CHANCE
MANUFACTURING CO., INC.

Ride: YO YO

Subject: GUSSET PLATE ADDITION

SERVICE BULLETIN

Subject: Tower Rooding Decal

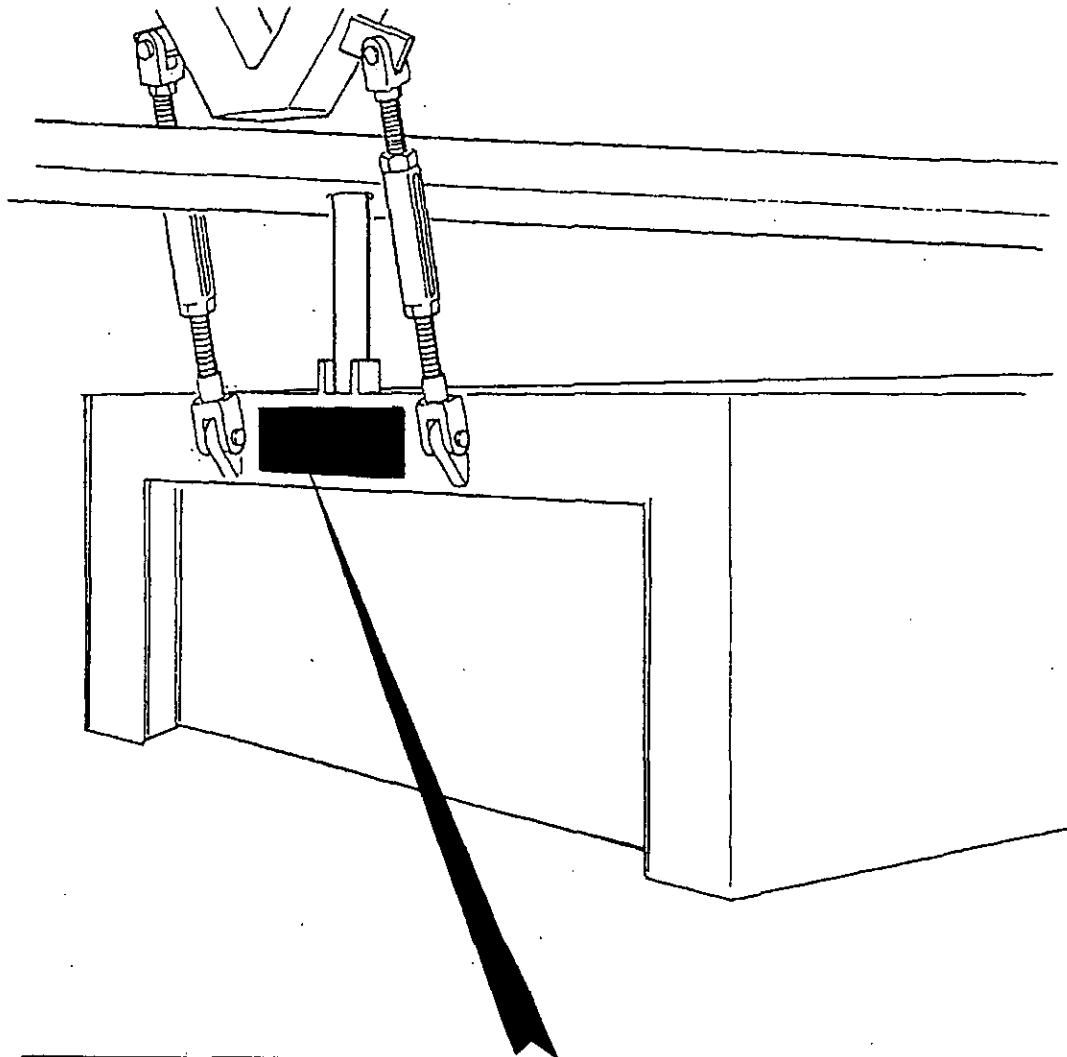
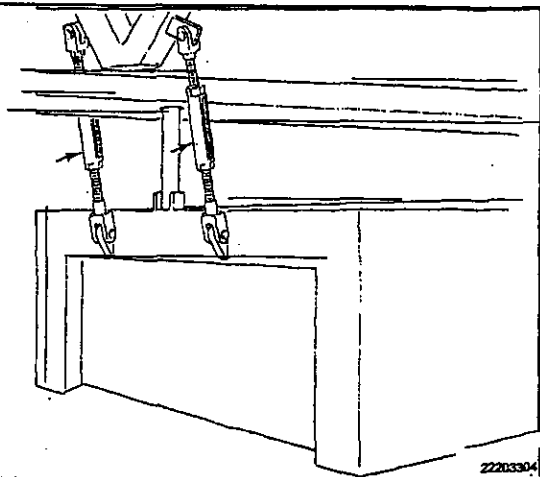
Portable YO-YO amusement rides are designed with turnbuckles to secure the top end of the tower to the trailer when the ride is in the rooding position. Failure to properly secure the tower for rooding, as shown in the operator's manual, could result in structural damage to the ride, the trailer or personal injury.

Chance Rides, Inc. has developed a decal to help alert owner/operators of the correct way in which to secure the YO-YO tower to the trailer for rooding. All owner/operators of portable YO-YO amusement rides are required to order and install this decal, part number 22203304, as outlined in this bulletin. One decal is required per ride and is free of charge if ordered within 90 days of the date on this bulletin.

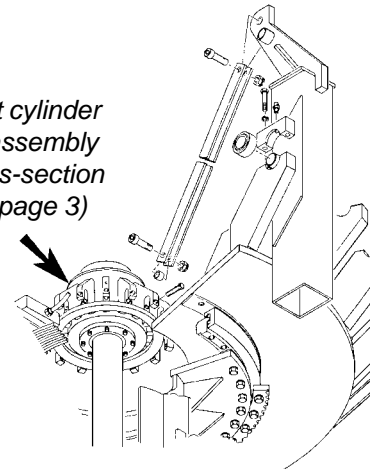
The sweeps on the YO YO connect to the sweep lift cylinder bearing assembly through the sweep links (the sweep lift cylinder bearing assembly is sometimes referred to as the “spider”). The bearing assembly is secured to the sweep lift cylinder rod by two bearing nuts, and further secured by LocTite® and a bearing lock washer. If the sweep lift cylinder bearing assembly comes loose from the cylinder rod, the sweeps will lower, which can result in personal injury to the passengers.

The design of this area has not changed in over 35 years of production. To date, 95 YO YO amusement rides have been built using this design. Chance Rides Manufacturing, Inc. believes that this time-proven design is sound and the ride is safe if all aspects of the design are maintained per the manufacturer’s specification.

The sweep lift cylinder bearing assembly and its connection to the sweep lift cylinder must be periodically inspected to ensure that the parts are functioning properly and that the connection is secure. A rework kit has been developed to make this periodic inspection easier. The rework also provides an additional means of retaining the bearing assembly to the cylinder rod.
